36/2-96D 9310 Brookville Road (REV)2/REV.3<sup>e</sup>  
Silver Spring (Wolfe House - Linden  
Historic District)

Wolfe House

<b>Address:</b>	9310 Brookville Road, Silver Spring	<b>Meeting Date:</b>	07/24/02
<b>Applicant:</b>	Thomas Kristie & Theodore Clements	<b>Report Date:</b>	07/17/02
<b>Resource:</b>	Linden Historic District	<b>Public Notice:</b>	07/03/02
<b>Review:</b>	HAWP	<b>Tax Credit:</b>	Partial
<b>Case Number:</b>	36/2-96D (Third Revision)	<b>Staff:</b>	Perry Kapsch
<b>PROPOSAL:</b>	Historic fence rehabilitation; masonry wall construction, rear fence modification.		
<b>RECOMMEND:</b>	Approve with conditions.

newel post  
4 1/2 square x 40 H  
chamfered edges

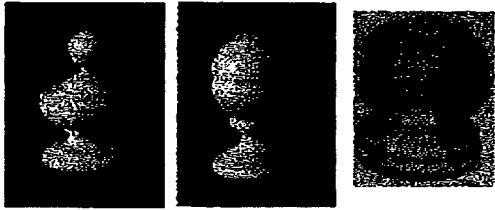
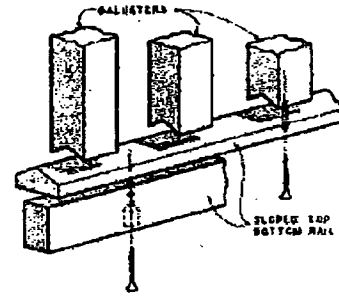
Attached are pictures/drawings of the balcony railing. We chose chamfered newels and balusters since that is the style of the front porch posts and interior staircase newels. The house originally had square picket balusters on the front (extended porch deck). The side porch drawing shows the crescent brackets we hope to use to support the small overhang tin roof.

*Hi Tom - I'm favoring back approvals  
for your choices - think they will  
be fine - Perry. (originals will  
be in the case  
file here.)*

Photographs of "parged wall"

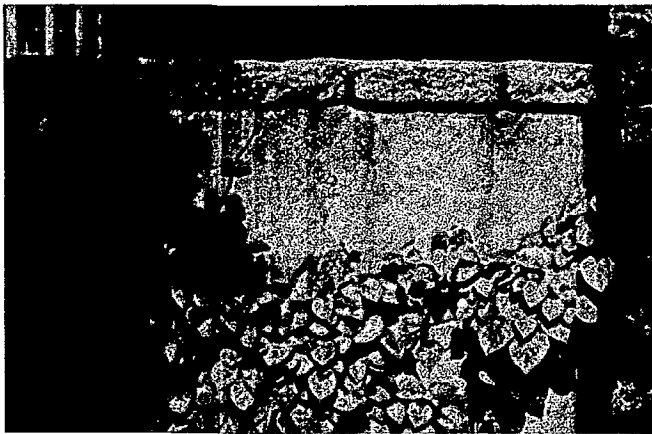
- A. The requested design change is from the approved brick piers with wood infill to a solid masonry wall (parged concrete with granite block cap). The fenceline will be integrated into the landscape with vegetation in the process of restoring the original garden areas of the house that were an important feature of the historic character and which were destroyed during subdivision of the original lot and construction of the adjacent homes (2102 and 2103 Salisbury Street). The wall will also be integrated with restoration of the original granite pier-"looped chain" fence to restore the original front view of the home (refer to attachments XX)

APPROVED  
Montgomery County  
Historic Preservation Commission

Relationship: house and patio/gardens to Brookville Road, Salisbury Road, and the original lot

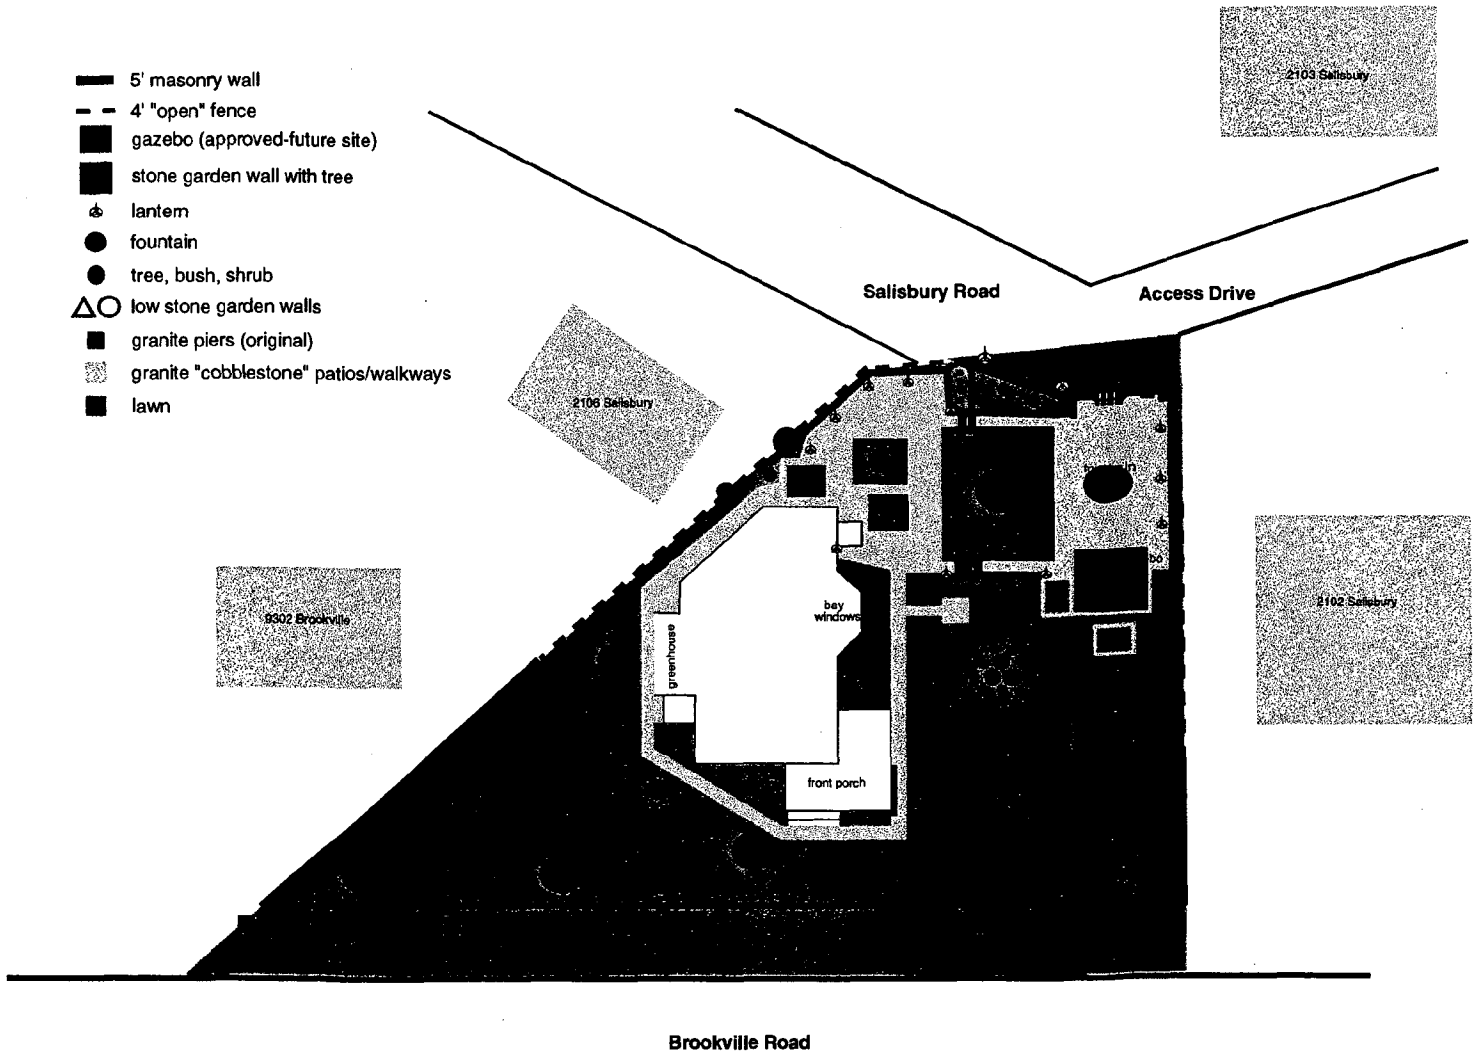
- 5' masonry wall
- - 4' "open" fence
- gazebo (approved-future site)
- stone garden wall with tree
- ⊕ lantern
- fountain
- tree, bush, shrub
- △○ low stone garden walls
- granite piers (original)
- granite "cobblestone" patios/walkways
- lawn

APPROVED  
Montgomery County  
Historic Preservation Commission  
*[Signature]* 2/24/02
